# 1956 AMC-Hudson

Groups 1.000 thru 13.000

# INDEX

FIGURE 1  
Approximate Location of 11/64" Diameter Holes  
Drilled in Timing Chain Cover

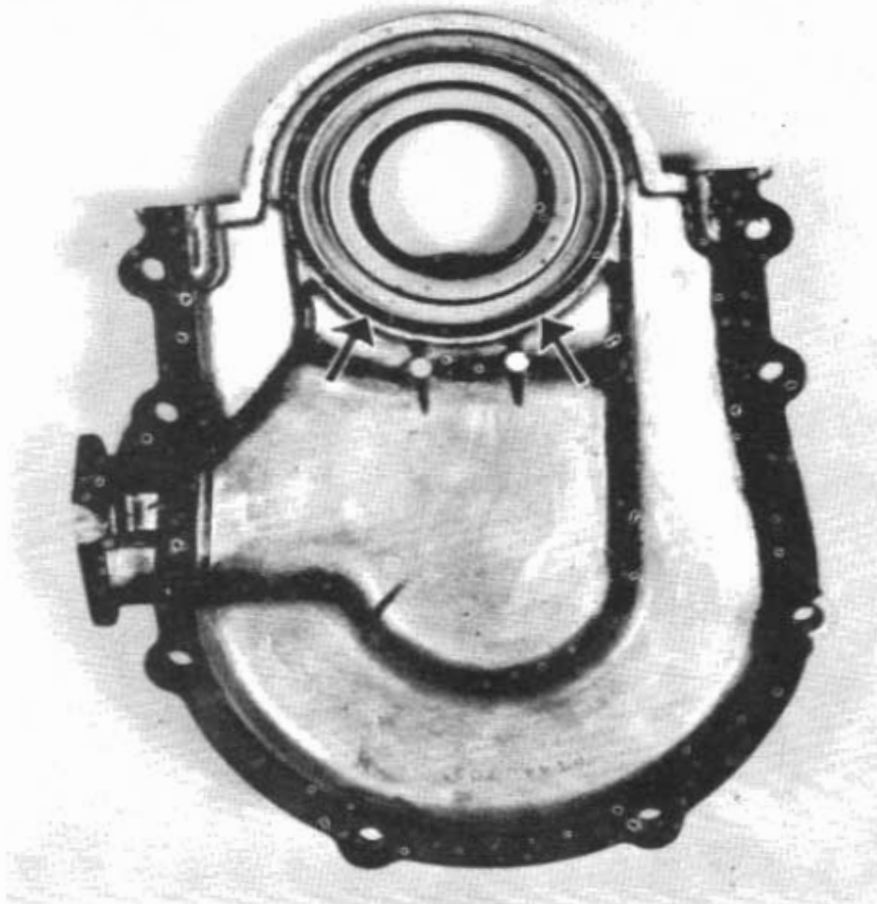
An oil leak at the front timing chain cover oil seal may result from a lack of an interference fit of the seal in the cover. This would permit the seal to turn with the crankshaft,

Remove timing chain from engine. Pry out old seal assembly from engine side of cover. Drill two 11/64" holes at location illustrated in Figure 1, American Motors Technical Service Att. #56-2.

FIGURE 2  
"Upset" Seal Material  
Into Drilled Holes in Cover

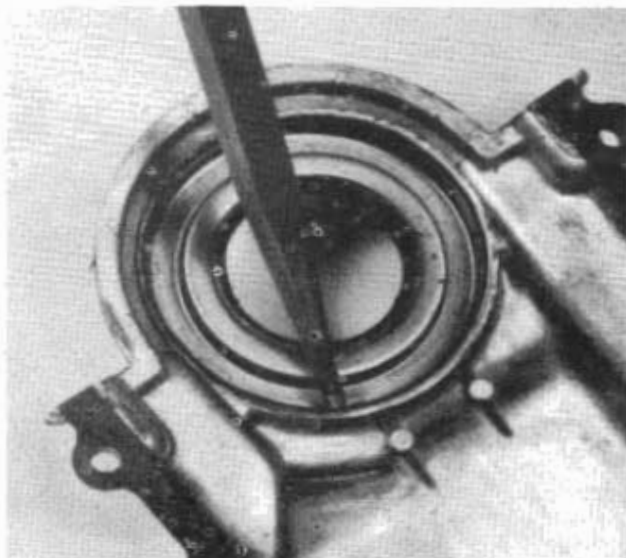
Install new oil seal with Tool J-5983. Upset the seal material into holes with a blunt pointed punch as shown in Figure 2.

FIGURE 1

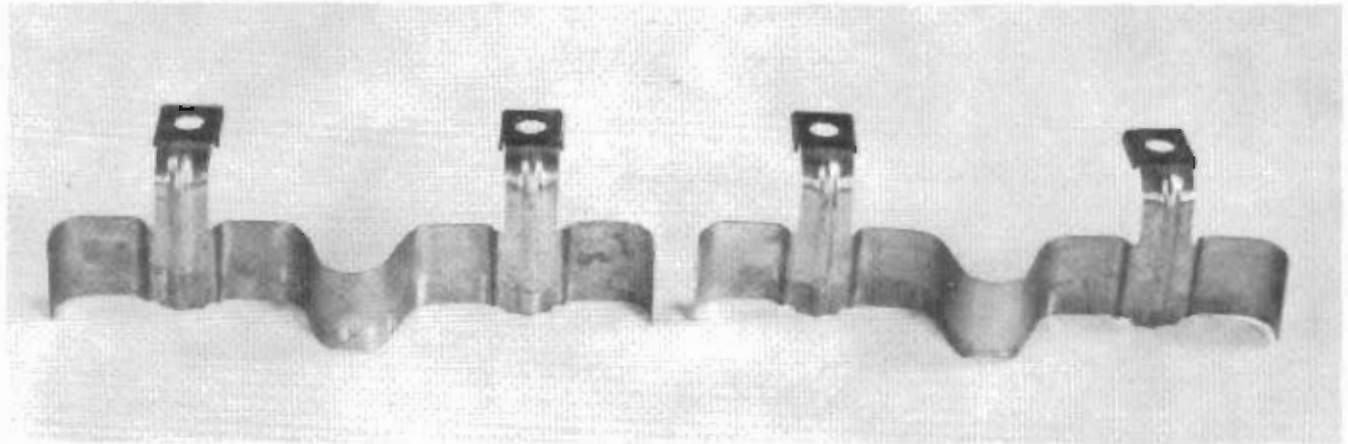
For service installation, WHERE VALVE GRINDING IS NOT REQUIRED, a special baffle kit, Part Number 6484396, consisting of 4 pieces valve spring baffle, Part Number 6489127, and 8 lockwashers, Part Number 6489048, may be installed without necessity of valve spring removal.

American Motors Technical Service Att. #56-8 illustrates the installation of the baffle contained in Part Number 6484396, Service Kit.

FIGURE 2

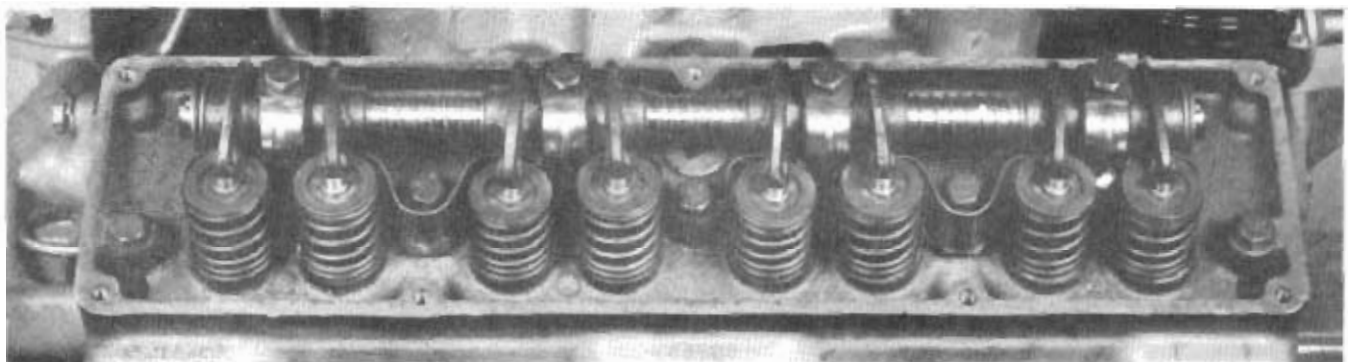
Place the baffles in position on the rocker arm assembly as shown in Figure 2. Install the assembly on the cylinder head. Replace the original rocker arm shaft bolt lockwashers with the square type lockwashers.

FIGURE 1

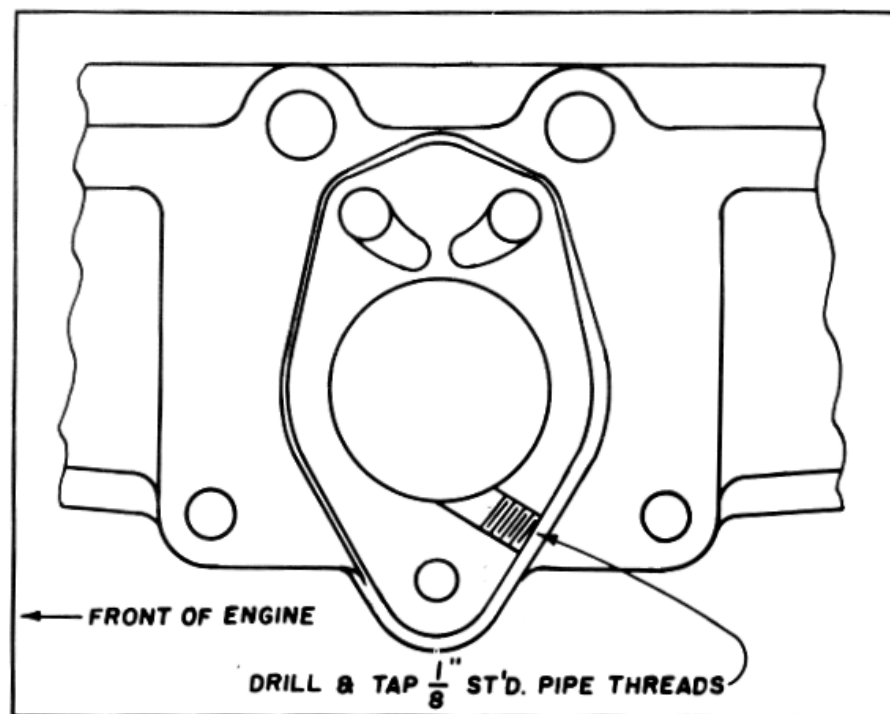
Mark and drill a  $21/64$ " hole in the left rear side of the carburetor mounting pad as shown in the illustration.

FIGURE 1  
CARBURETOR THROTTLE ROD AND  
ADJUSTER ROD MEASUREMENT

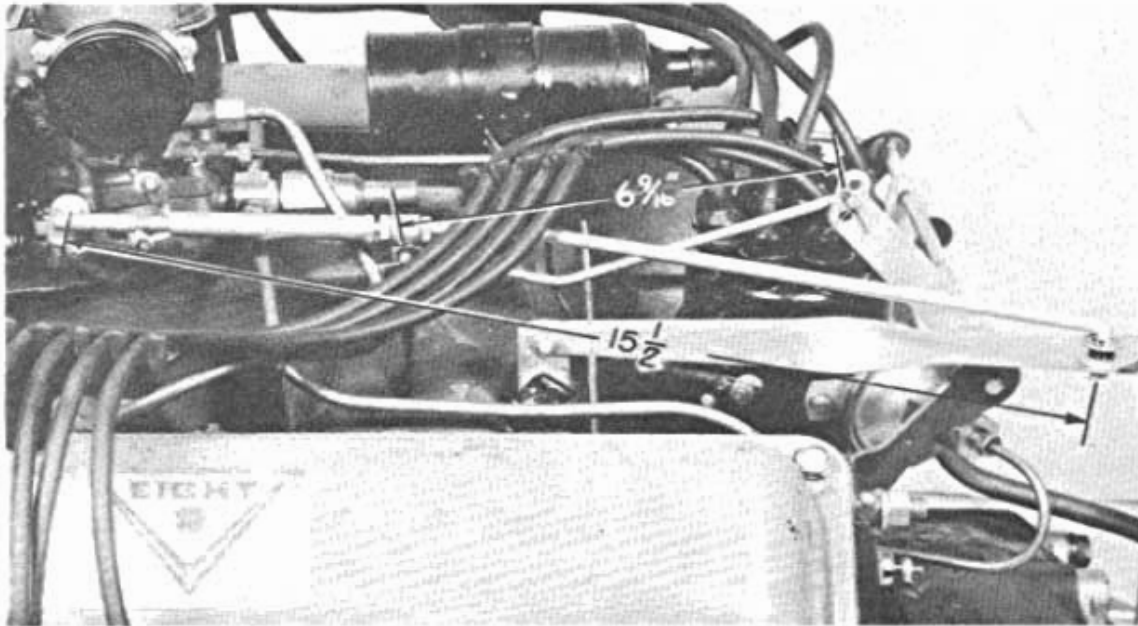
The adjuster rod that is connected to the carburetor throttle rod and to the lever of the cross shaft must be 6-9/16" from center to center of ends of rod. If the rod is either too long or too short, bend rod at present bend to obtain the correct length of 6-9/16".

FIGURE 2  
T.V. ROD MEASUREMENT

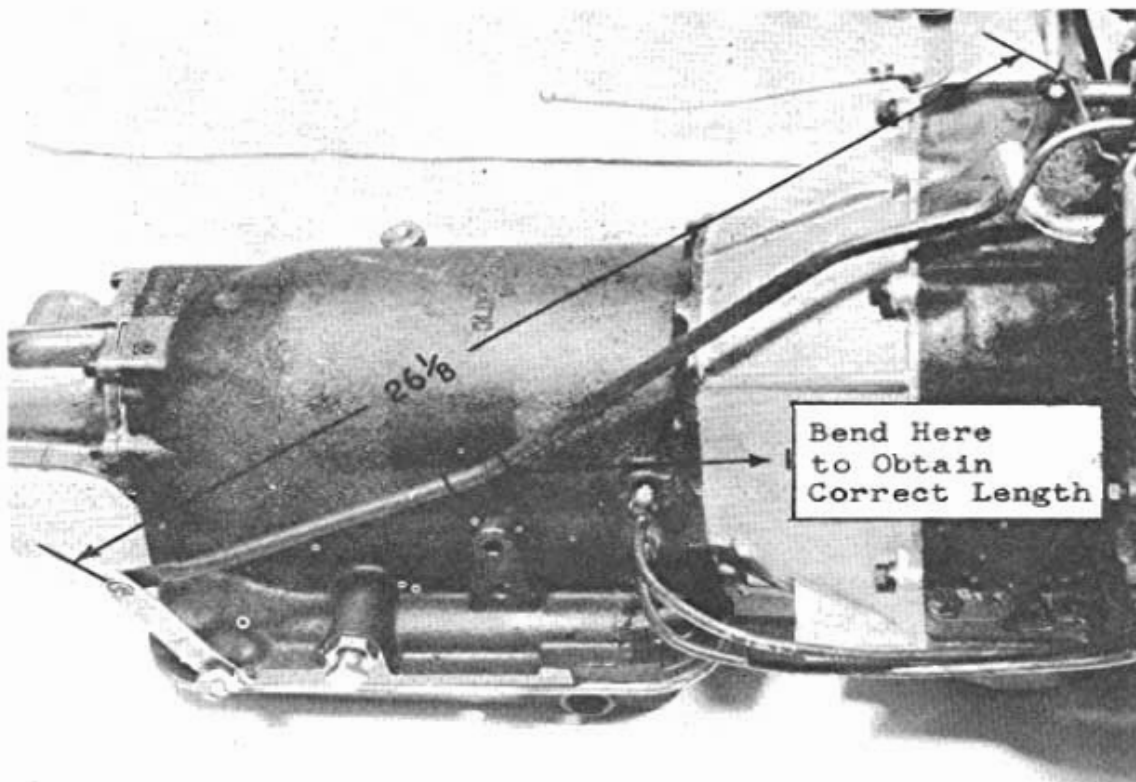
The T.V. rod from the cross shaft lever to the T.V. lever at the transmission must be 26-1/8" from center of pins, This rod must also be bent to obtain the correct measurement (Fig. 2).

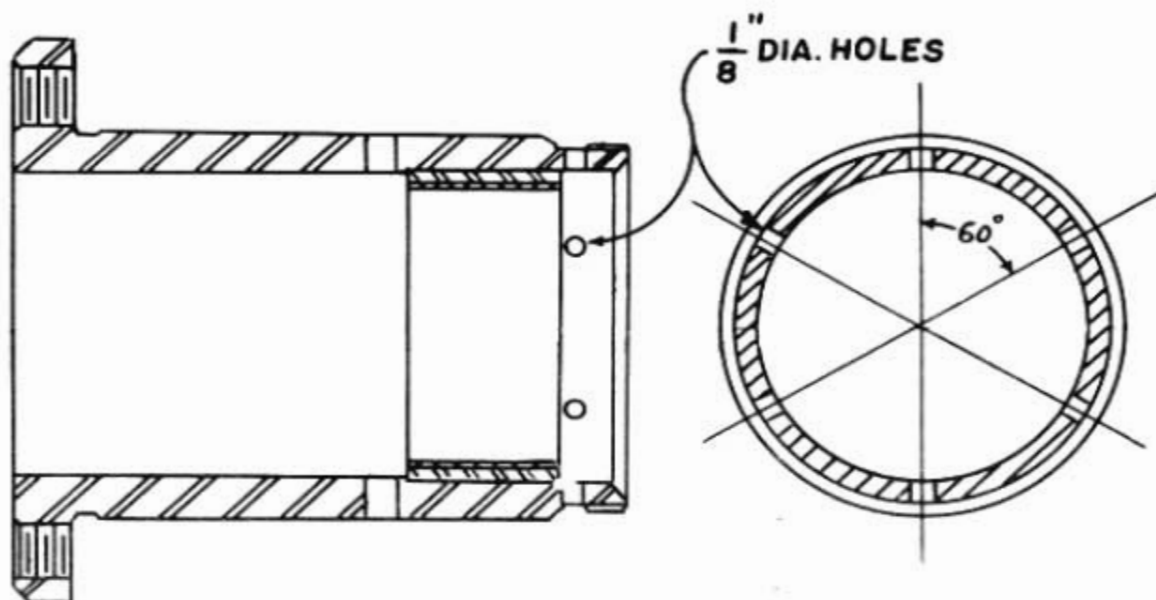
Where it is found necessary to replace a new pump assembly, Part Number 6484527, or a new rotor assembly, Part Number 6469367, in the 1955 Series, the original converter pump shaft MUST be drilled with six 1/8" holes properly indexed in six places in the groove behind the splines as illustrated in American Motors Technical Service Att. #56-7. After drilling, all burrs and sharp edges must be removed.

# REAR INTERNAL GEAR

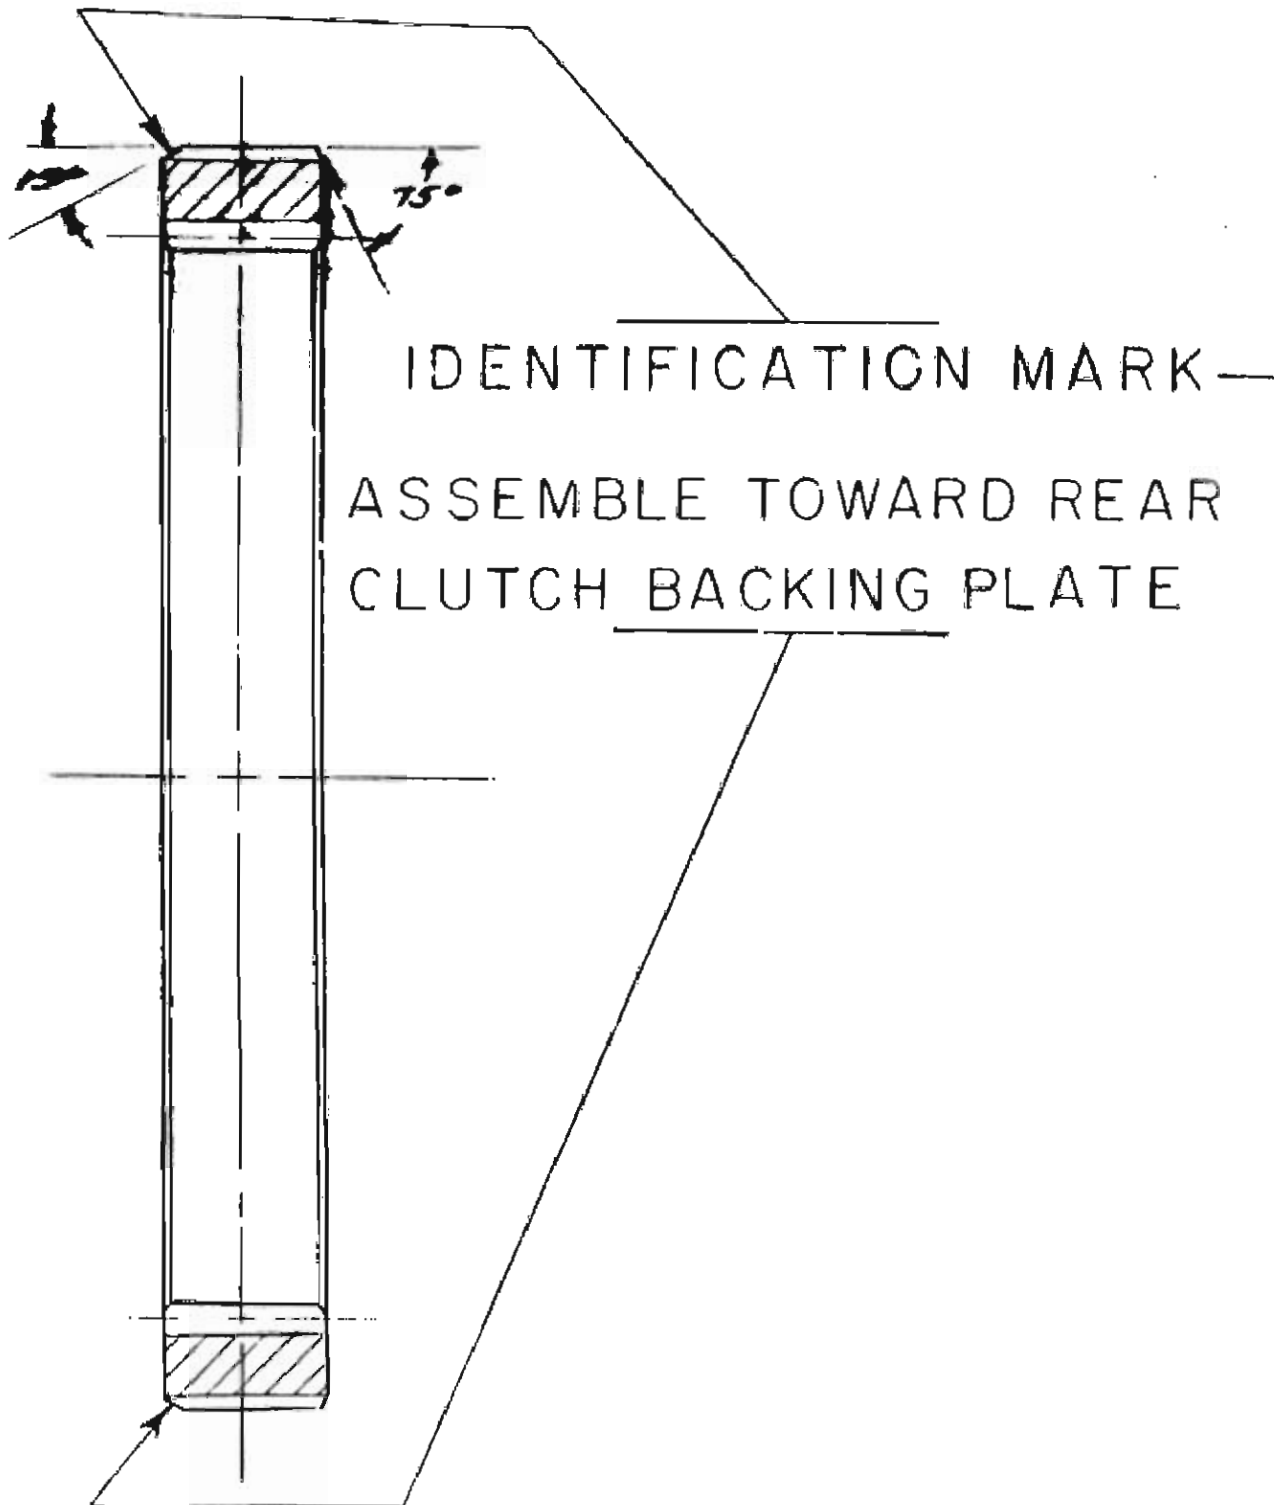
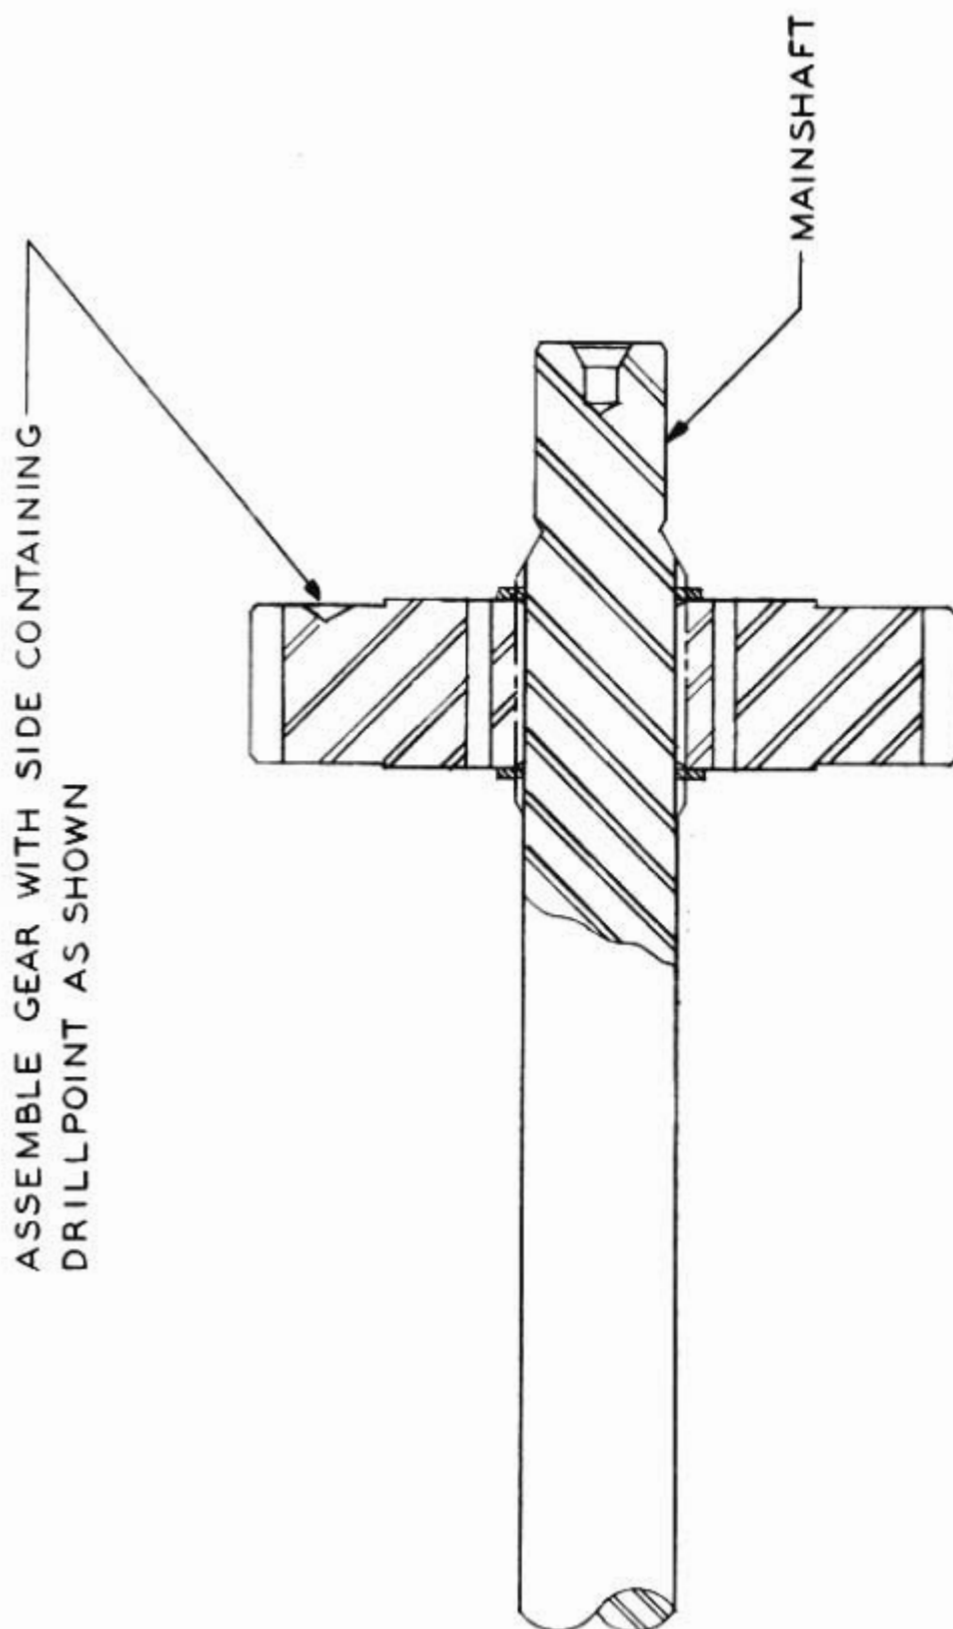
A 15° chamfer has been added to the front leading edge of the rear internal gear as illustrated in American Motors Technical Service Att. #56-17.

A .25 drill point has been added to the rearward side of the rear sun gear. This has been done for identification purposes.

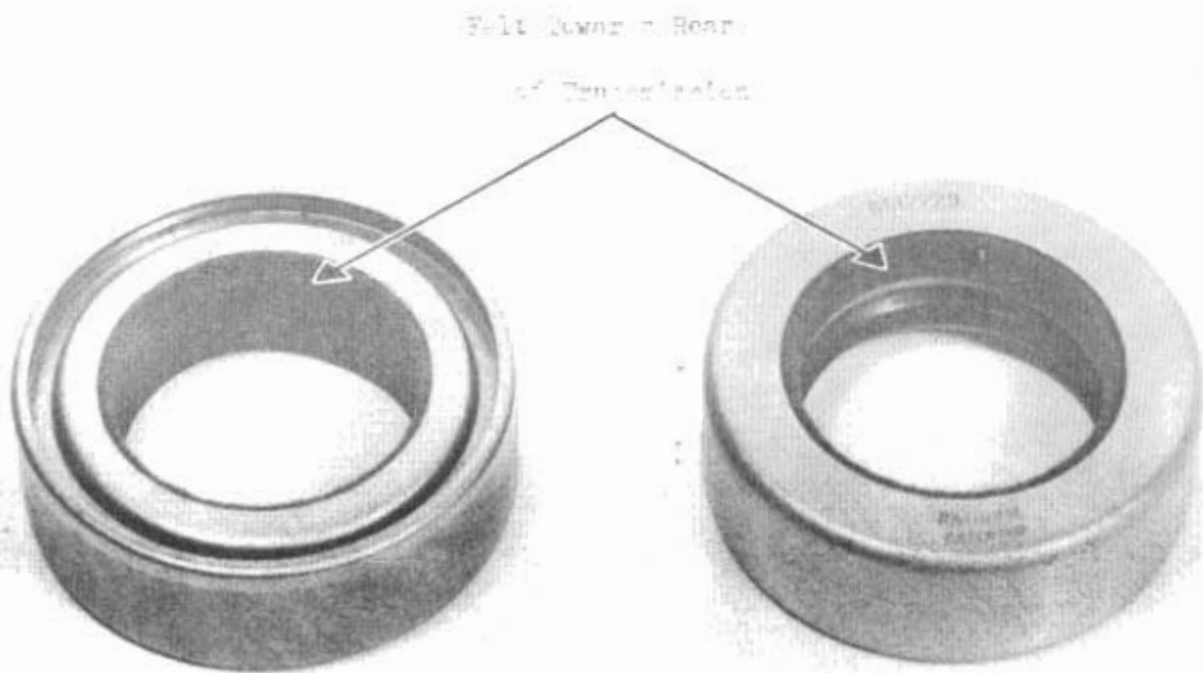
The assembly of these seals by the vendors differ, when installing the rubber, spring, and felt in the outer shell. American Motors Technical Service Att. #56-19 illustrates both seals.

Therefore, when replacing oil seals, the felt portion should always be positioned towards the rear of the transmission.

FIGURE 1  
Shock Absorber Lower Mounting  
Bracket Brace

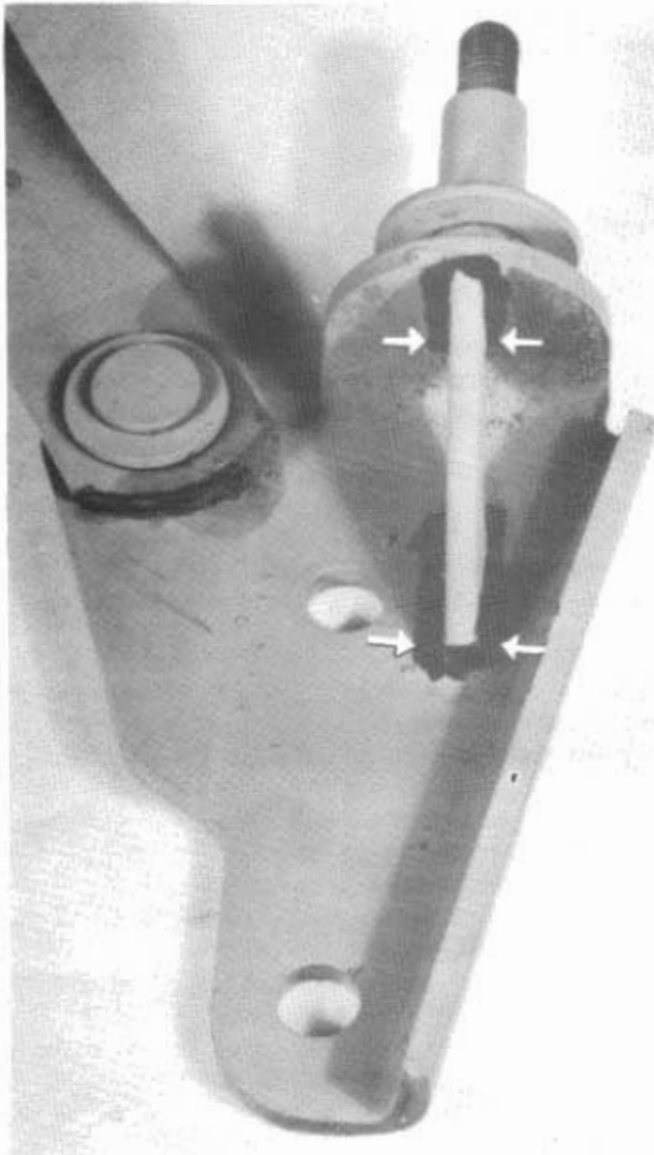
Effective at car serial number D-277527, a brace, Part Number 3148777, was added to the rear axle truss rod and shock absorber bracket to prevent bending of the bracket and resultant shock absorber damage.

Figure 1, American Motors Technical Service Att. #56-3 outlines the welding location of the brace.

FIGURE 2  
Shock Absorber  
Upper Mounting Reinforcement

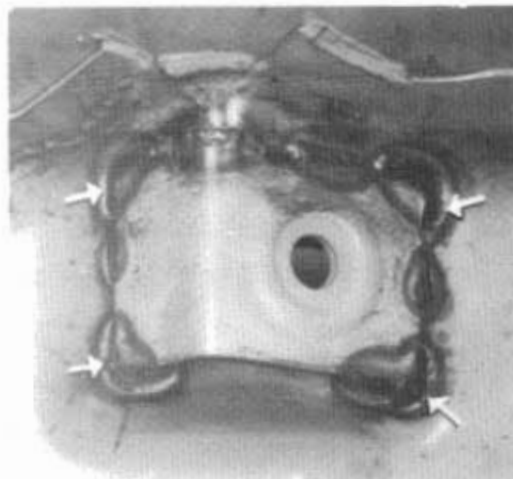
A reinforcement, Part Number 3415299, has also been added to the body crossmember at the point where the upper end of the rear shock absorber is attached. This reinforcement was added in production at car serial number D-279100.

To install the shock absorber upper mounting reinforcement, remove the rear shock absorbers. Remove the original shock absorber grommet retainer welded to the underside of the crossmember. The reinforcement is formed to take the place of the lower grommet retainer.

Use a bolt and nut through the shock absorber bayonet hole to hold the reinforcement in place while arc welding. Figure 2 outlines the location and welding of the reinforcement.
